**Subject: Amended MHI's Response to US-APWR DCD RAI No. 354-2585
Revision 0**

**US-APWR Design Certification
Mitsubishi Heavy Industries, Ltd.
Docket No. 52-021**

RAI NO.: NO. 354-2585 REVISION 0
SRP SECTION: 06.02.02 – Containment Heat Removal System
APPLICATION SECTION: 6.2.2 & 6.3
DATE OF RAI ISSUE: 05/07/2009

QUESTION NO.: 06.02.02-24

Figure-1 Gratings important to prevent the credible large debris from block the refueling cavity drains (inside secondary shield wall)

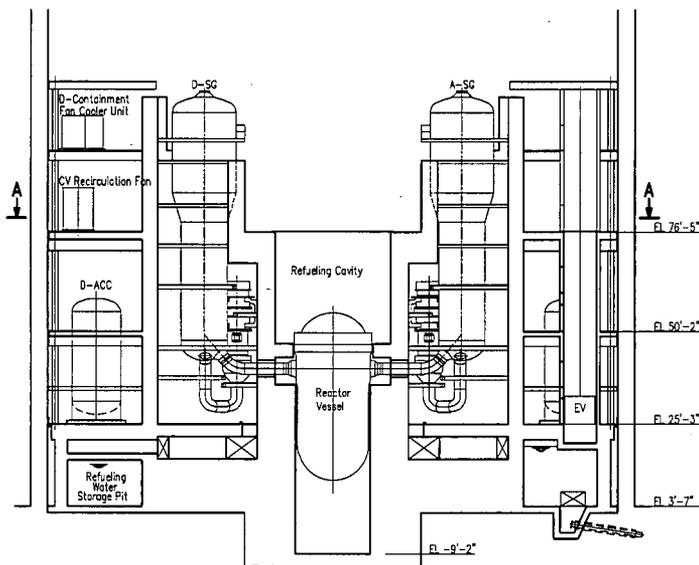
4) As per interaction with staff in the conference call on September 30 2009, MHI is to clarify how the US-APWR prevents the refueling cavity drains from blocking by large debris. If MHI is going to crediting the gratings, discussion will be needed to identify which grating is important and how the grating will be maintained during plant operation. Following is the updated response to the question:

- Given that pipe break inside secondary shield walls, layer of gratings at elevation 55'-1" and 73'-1" (See Figure-1), The grating at 55'-1" prevent large debris from blowing out through opening on the floor opening at 76'-1", which is located just above the reactor coolant pump. The grating at 73'-1" prevent large debris, except the fibrous insulation installed on main steam pipe support at top of secondary shield wall, from blowing out through steam generator compartment opening. Therefore, only "small" debris, except fibrous insulation on main steam pipe support at top of secondary shield wall, can be transported on the operating floor or refueling cavity.

- Grating inside secondary shield wall at EL. 55'-1" (Roop-A,B,C, and D)
- Grating inside secondary shield wall at EL. 73'-1" (Roop-A,B,C, and D)
- Grating at upper core internal laydown pit (in refueling cavity)
